ELECTRONIC DETERMINATION BUSINESS PAPER

LOCAL PLANNING PANEL MEETING

2 ELECTRONIC - DA/123/2021 - TORRENS TITLE SUBDIVISION OF ONE ALLOTMENT INTO TWO - 11 ADAMSON AVENUE, THORNLEIGH

DA No: DA/123/2021 (Lodged on 5 February 2021)

ATTACHMENT B | PLAN OF SUBDIVISION

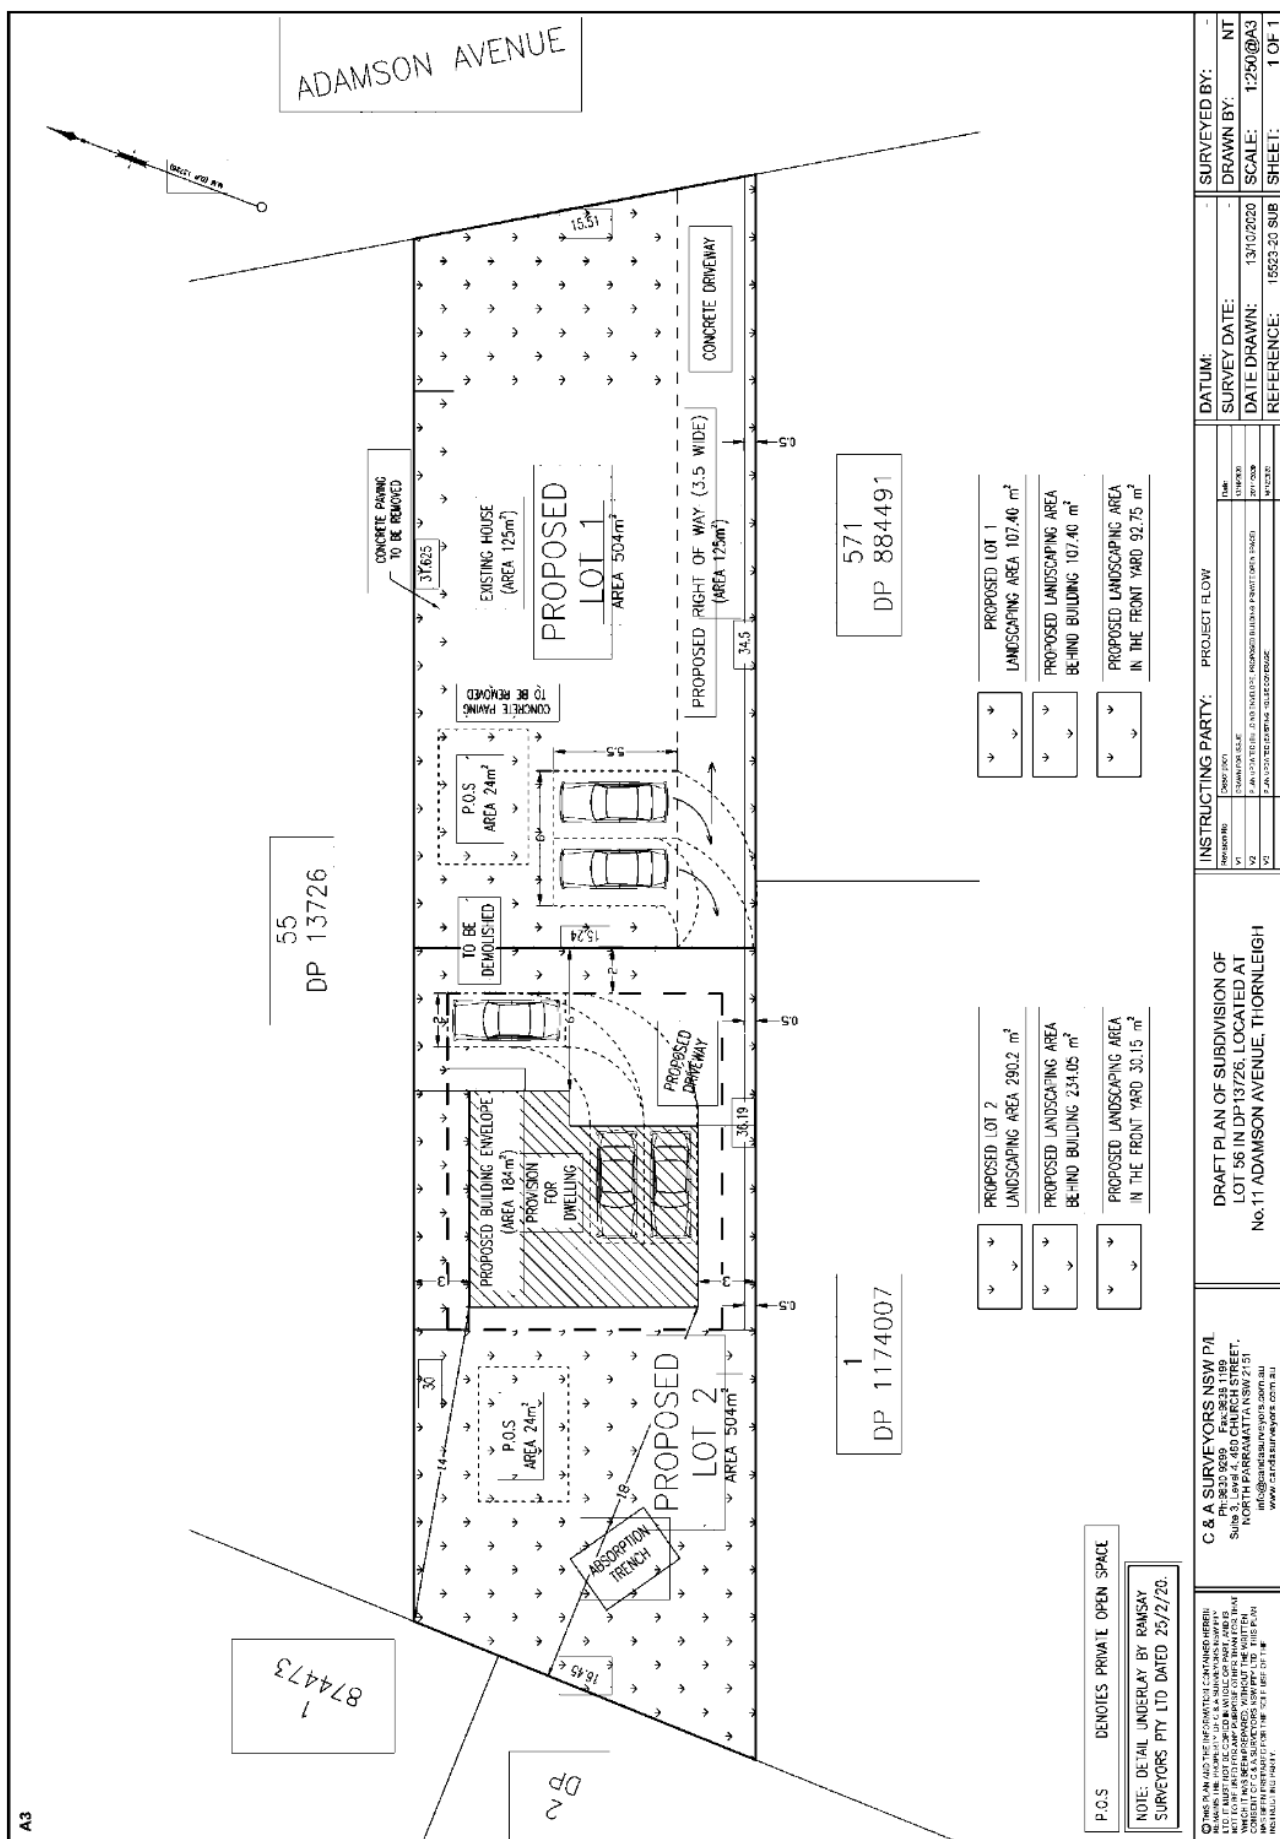
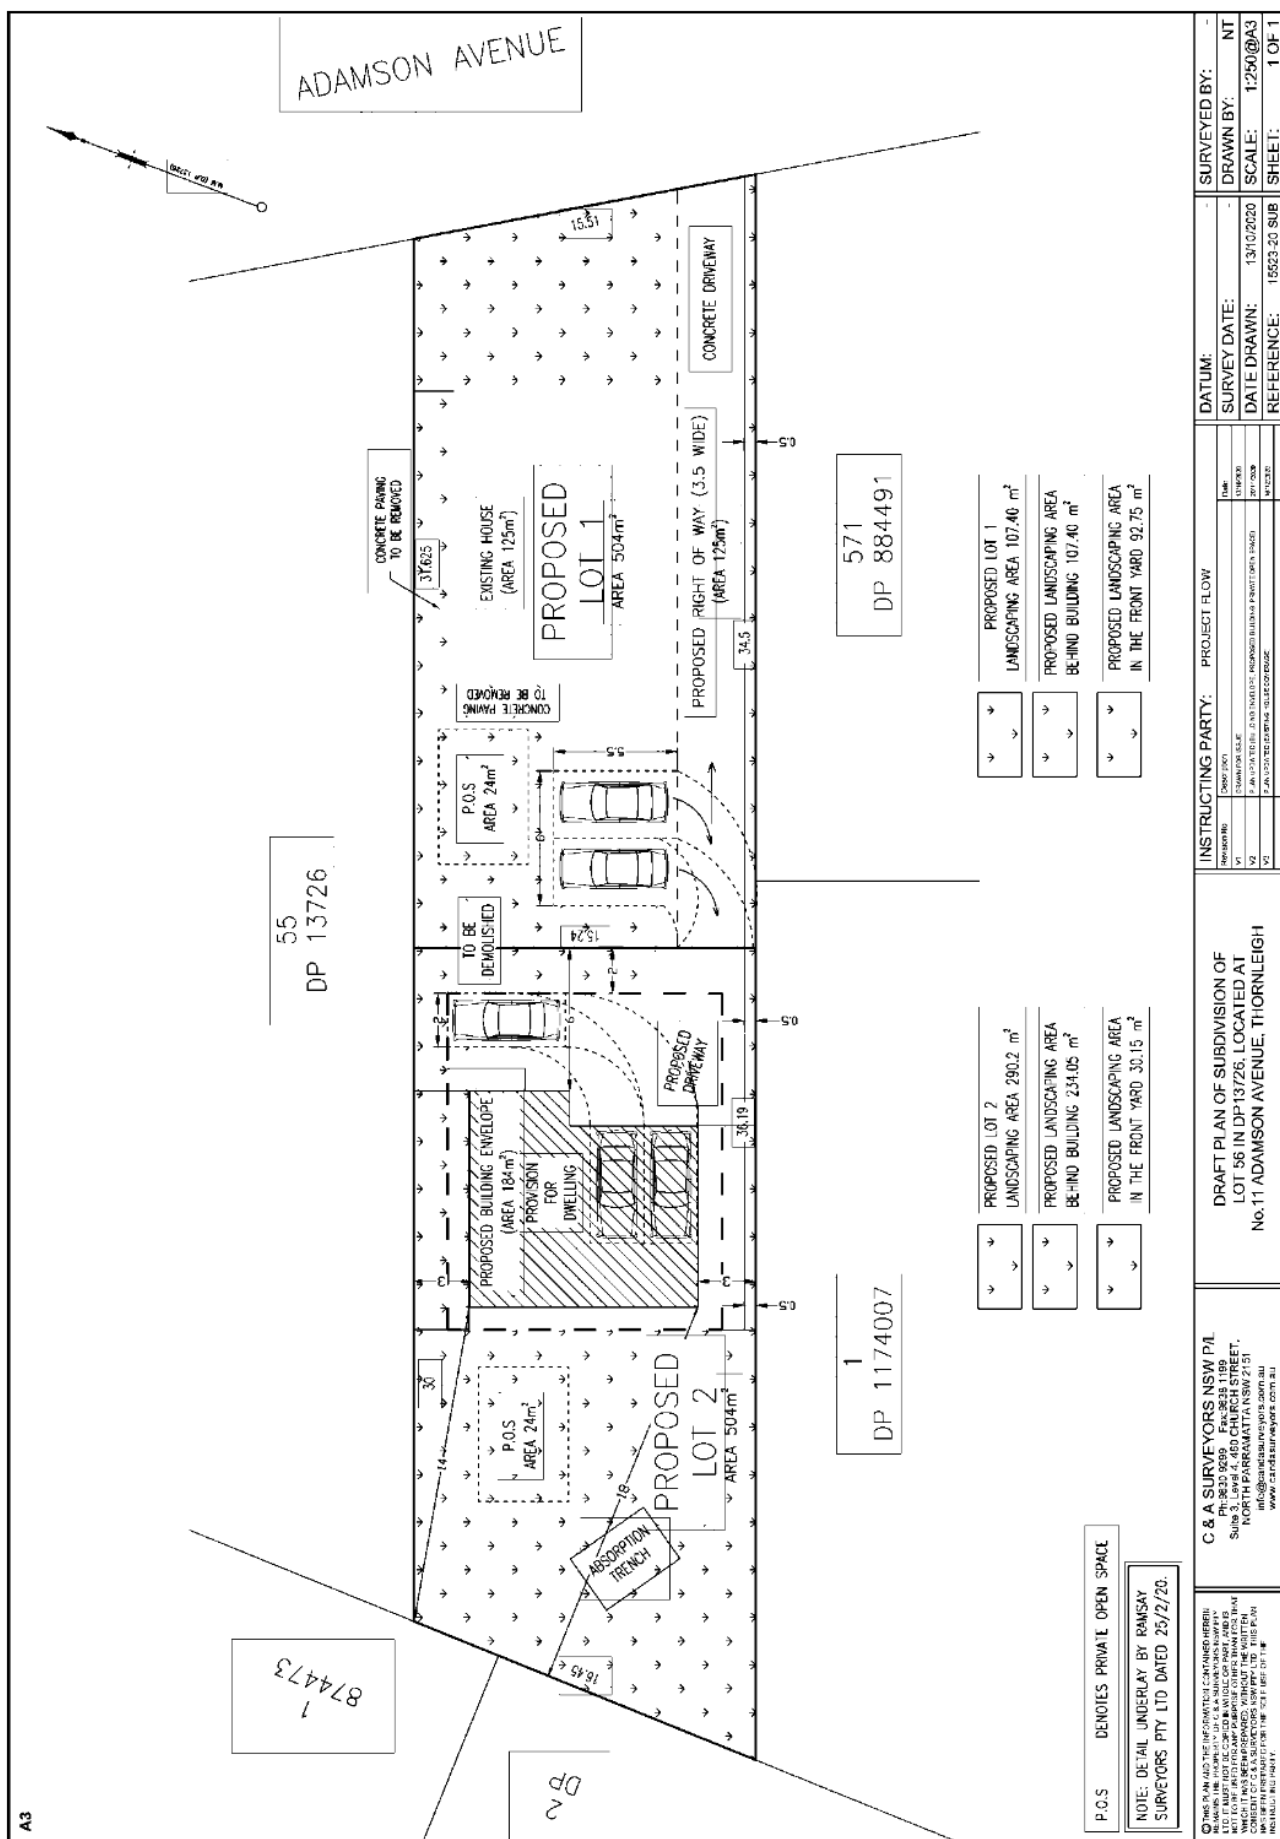
The submitted Subdivision Plan indicates a 184m² indicative building envelope on proposed Lot 2 (comprising a future dwelling and vehicle turning area).

As identified in Table 2.6 of this report, Council's assessment of the submitted Subdivision Plan has concluded that an 88m² building envelope is shown on proposed Lot 2, which is contrary to the minimum 200m² requirement. Council's calculation of the building envelope has excluded the vehicle turning area and has solely included the building footprint.

The stormwater drainage plans prepared by MBC Engineering Pty Ltd Building, Civil and Structural Engineers have proposed an on-site absorption system to be located at the rear of proposed Lot 2. Section 1C.1.2 of the *HDCP* requires that where a property slopes away from the street and there is no inter-allotment drainage system or Council drainage system, the development is required to obtain an inter-allotment drainage easement over the downstream properties to pipe stormwater flows to the nearest Council system. In this case, the nearest Council system is a Drainage Easement located within No. 14A Sefton Road. The application does not comply with the *HDCP* in this regard.

- 4.3 The proposal does not comply with the 'Stormwater Management' prescriptive measures within Parts 1C.1.2(f) and (g) of the *HDGP* as an inter-allotment drainage easement is required over the downstream property to service the proposed subdivision. Insufficient information has been provided in the form of written consent from the downstream property owners and suitable hydraulic plans.
